## ANN ARBOR HISTORIC DISTRICT COMMISSION

### Staff Report

**ADDRESS:** 203-205 North Ingalls, Application Number HDC19-108

**APPLICATION:** The applicant seeks HDC approval to install sashes for 22 wood windows that were removed and replaced with modern windows without a certificate of appropriateness or building permits. The sashes are replicas of the historic windows that were removed, and would replace the modern windows currently installed.

MUNTIN CROSS SECTION

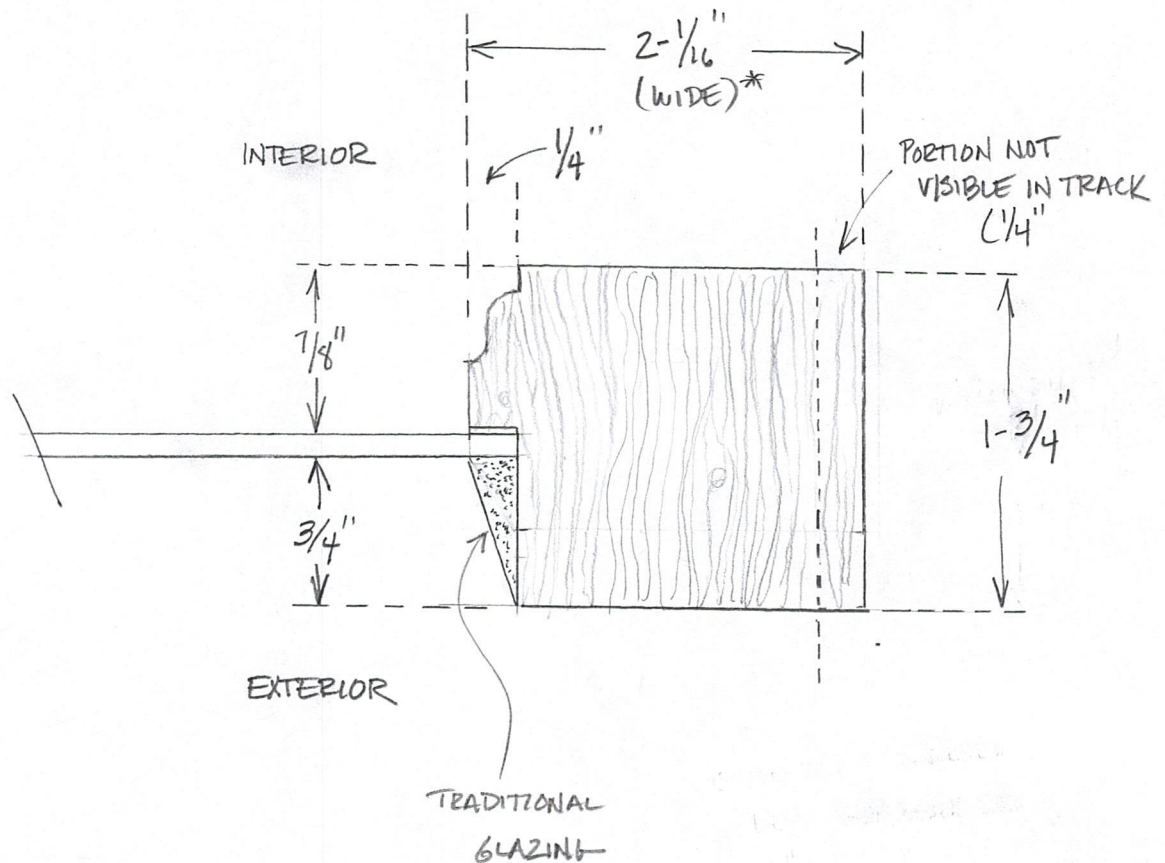
4. A proposal and sash detail drawings, along with a window worksheet, have been provided by the applicant's contractor, Dustin Schultz of 4D Home Improvements LLC. The sashes are near-replicas of the historic ones and meet the specifications for replacement of historic windows. They are true divided light, single paned windows. The
